**E1467A-01**

**S E R V I C E N O T E**

**E1467A 8x32 Relay Matrix Switch**

**E1467A may fail to open/close relays because of a defective relay driver IC with date code 0325**

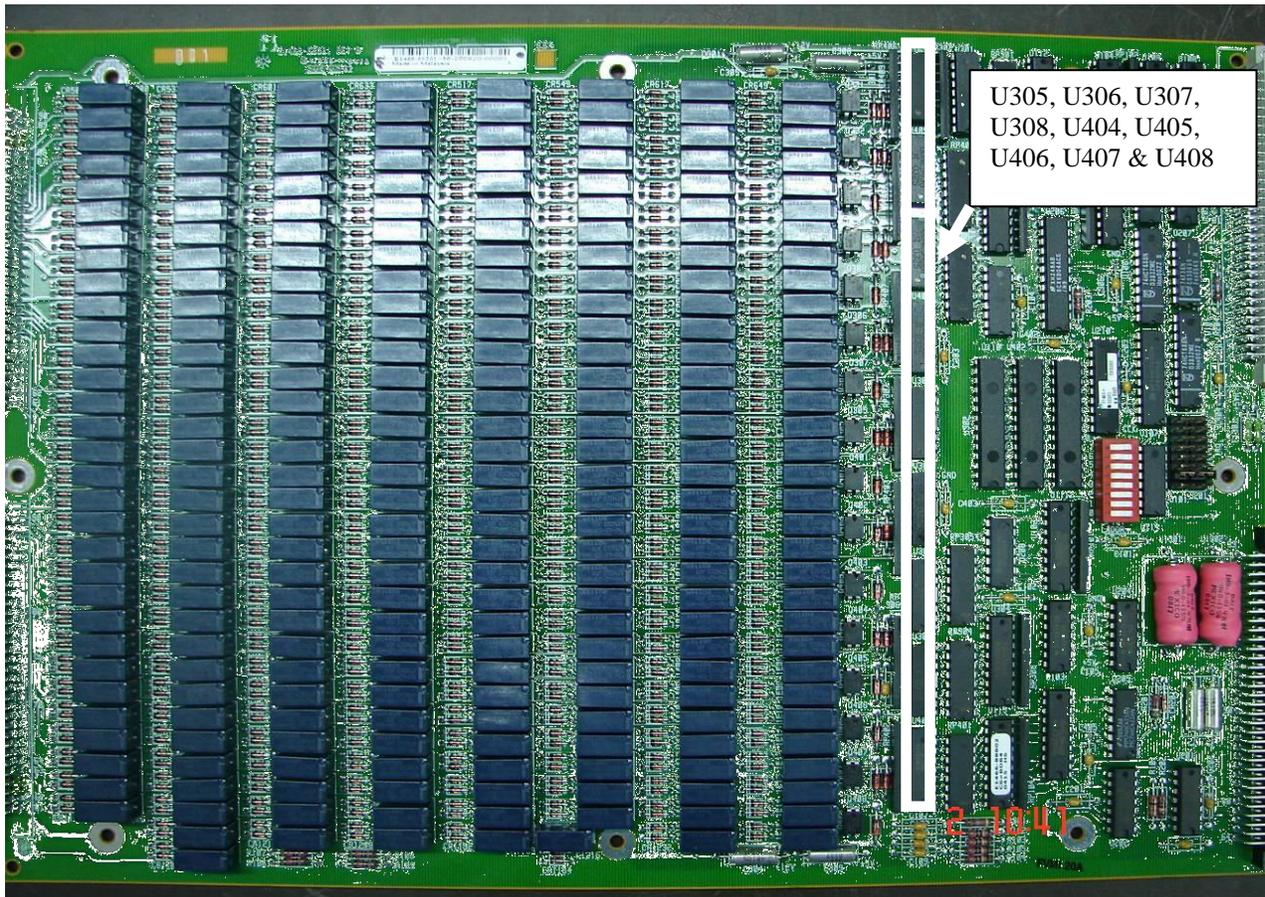
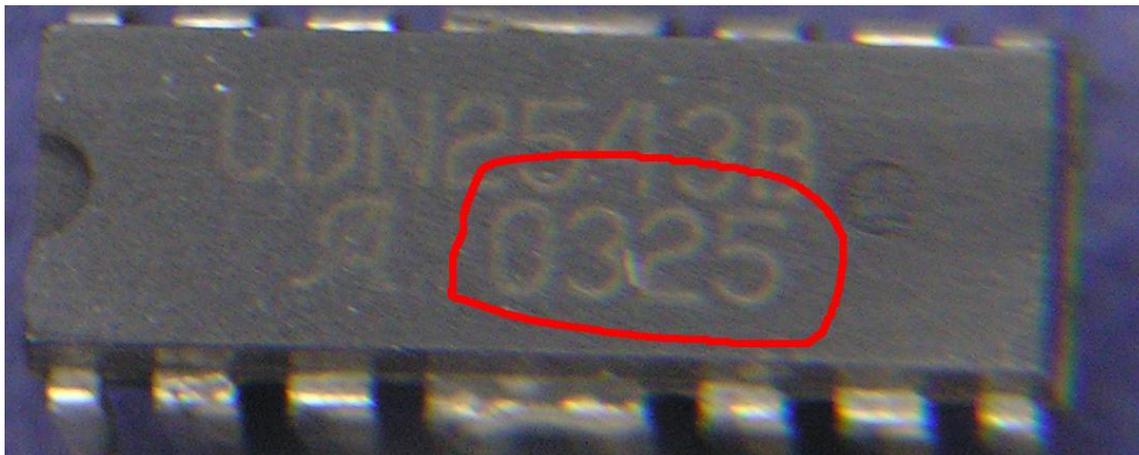
New E1467A shipped between approximately March 2008 and May 2009 may contain a relay driver .chip with a known date code problem.

The service repair part E1466-66701 used for repair during this time frame may also have the bad date code ICs.

The relay driver ICs are U305, U306, U307, U308, U404, U405, U406, U407, and U408 which are the LTB part 5188-2550 for 1820-4599.

The bad date code is 0325. This date code has a higher than normal failure rate. Most failures have occurred in the first three months of usage. See the following pictures for part and date code location

Part Number	: E1466-66501
Location Impacted	: U305, U306, U307, U308, U404, U405, U406, U407 & U408
Reject Criteria	: DC 0325 on IC

A E1467A that fails to close or open it's relays and has the 0325 date code ICs should be replaced with a E1466-66701.
